# Value Engineering Study Report

## Federal Aid Projects: I-75/Union Grove Road Interchange

## South Calhoun Bypass

RE: Submittal of Value Engineering Study Report  
Project Task Order No. 10 – Contract TOOESV06796  
Project I-75/Union Grove Road Interchange  
**Project No.** NH-75-3(203) – P.I. Number: 610870  
Project South Calhoun Bypass  
**Project No.** STP-00MS(7) – P.I. Number 662510  
County Gordon

DESCRIPTION: **CONSTRUCT EB ROADWAY FROM SR 53 TO US 41 FOR** SHEET NO.: **2 of 6**  
**TWO-WAY TRAFFIC**

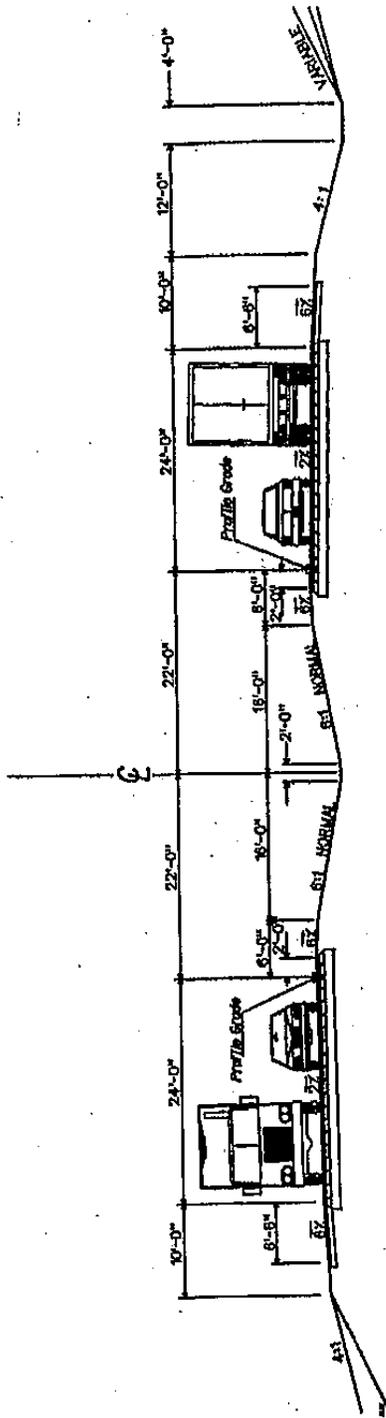
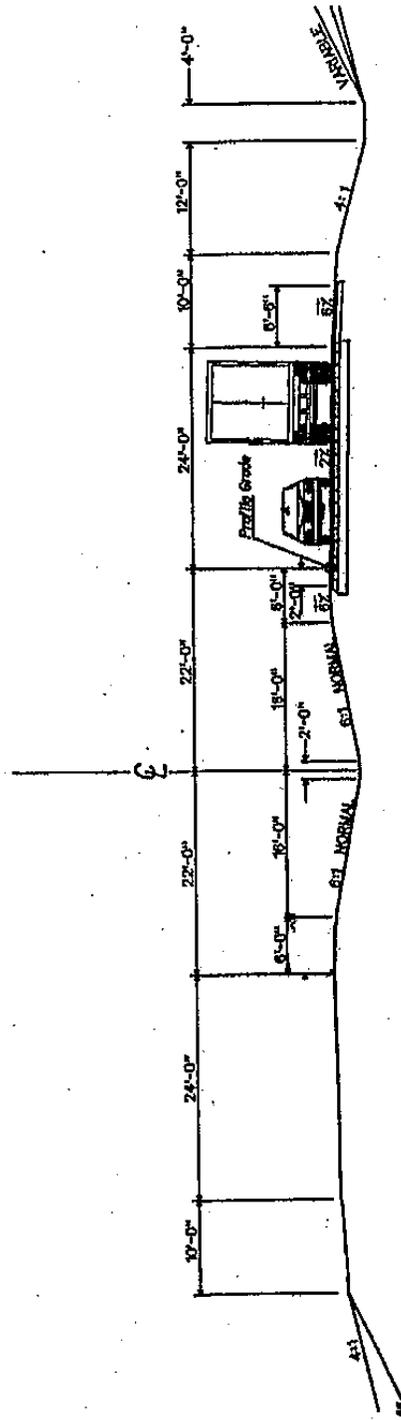
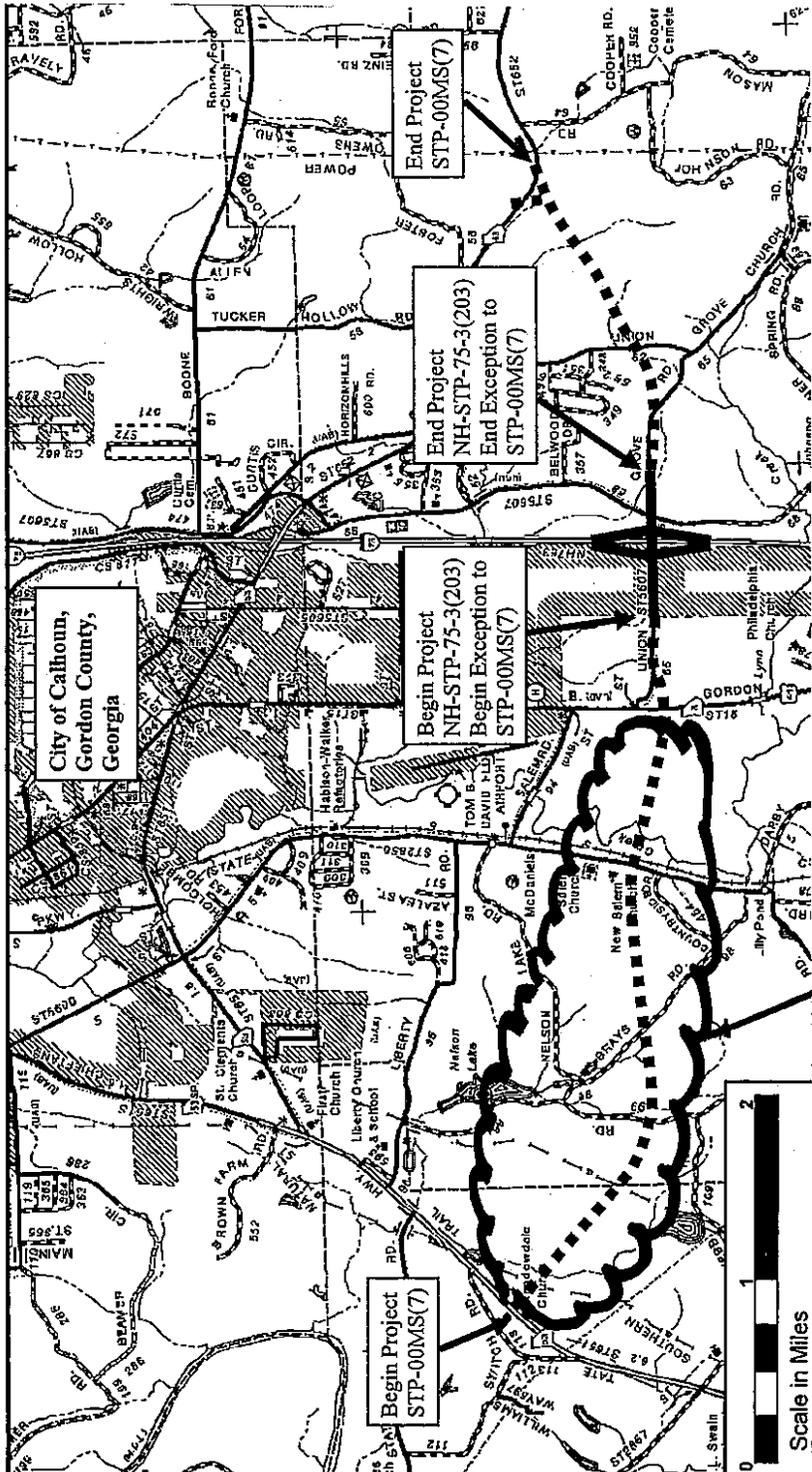
The revised concept report shows traffic volumes between 4,750 VPD. Traffic diagrams indicate highest volumes are in the industrial area which will be accessed by US41 and the new interchange on I-75. A two-lane section between SR 53 and US 41 would be adequate.

DESCRIPTION: **CONSIDER USE OF 3:1 FILL SLOPES IN AREAS WHERE** SHEET NO.: **2 of 2**  
**CLEAR ZONE REQUIREMENTS CAN BE MET BEYOND TOE OF SLOPE**

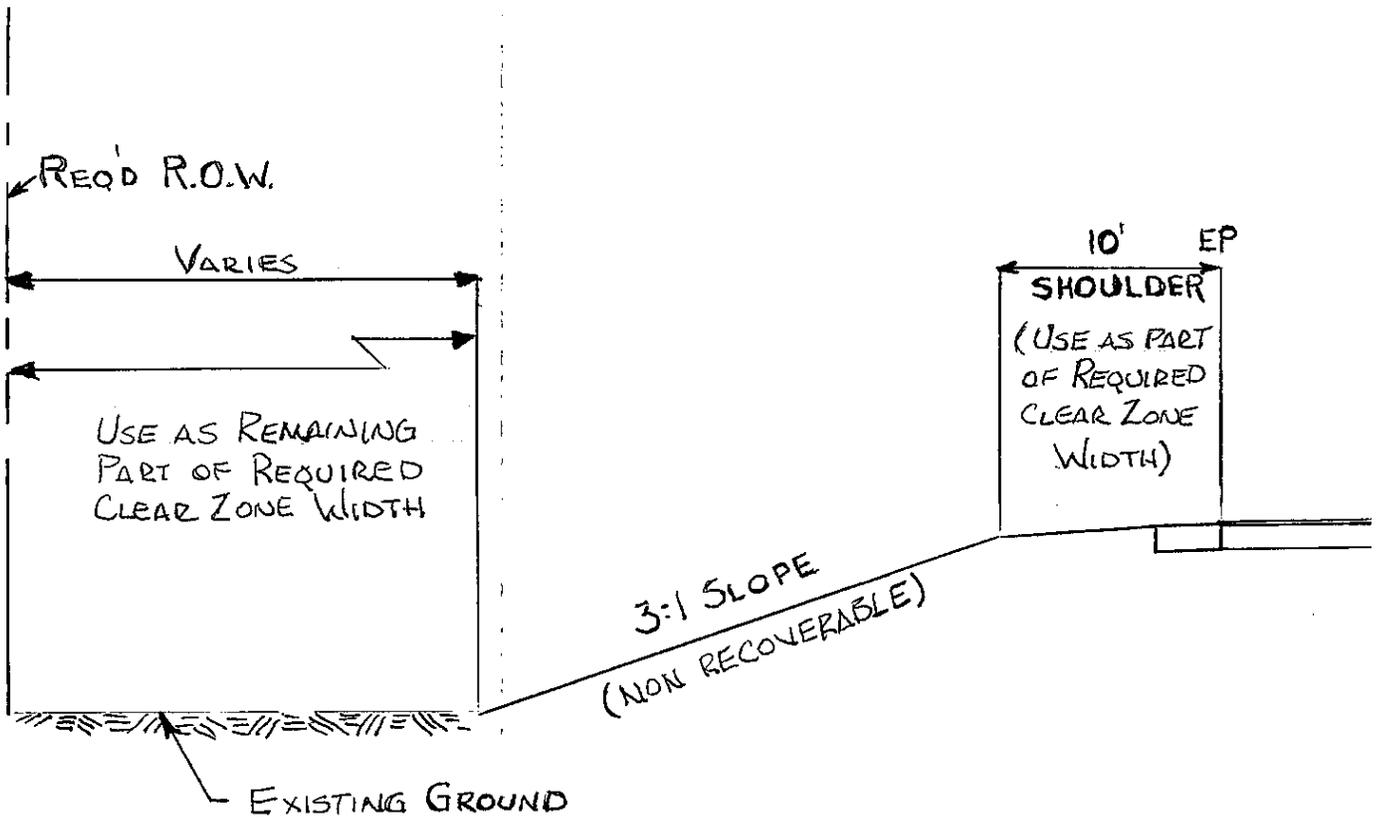
3:1 fill slopes are non-recoverable slopes as defined in the AASHTO Roadside Design Guide. However, it appears there are locations on the project where there are flat or near flat areas between the toe of fill slope and required right-of-way. This area can be used as a clear zone as long as it is properly maintained and no large vegetation is allowed to grow. This should reduce the amount of required 2:1 fill slopes, thus reducing the amount of required guardrail and fill.
